RE: Draft Chemical Fate and Transport Modeling Study Report
San Jacinto River Waste Pits Superfund Site, Harris County, Texas
Unilateral Administrative Order, CERCLA Docket No. 06-03-10

Draft Chemical Fate and Transport Modeling Study Report dated February 2012

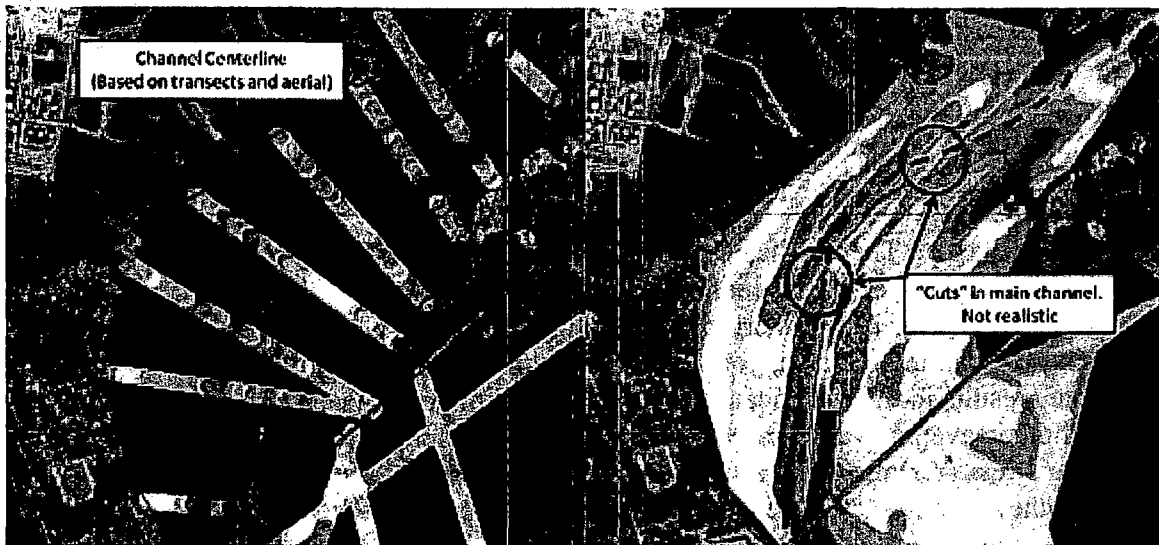
83. **(Appendix A):** With regard to Figure A-3, upstream bathymetric interpolation cuts the main channel twice near Grennel Slough (see figure below). This may affect upstream flow conditions and as such shall be investigated.
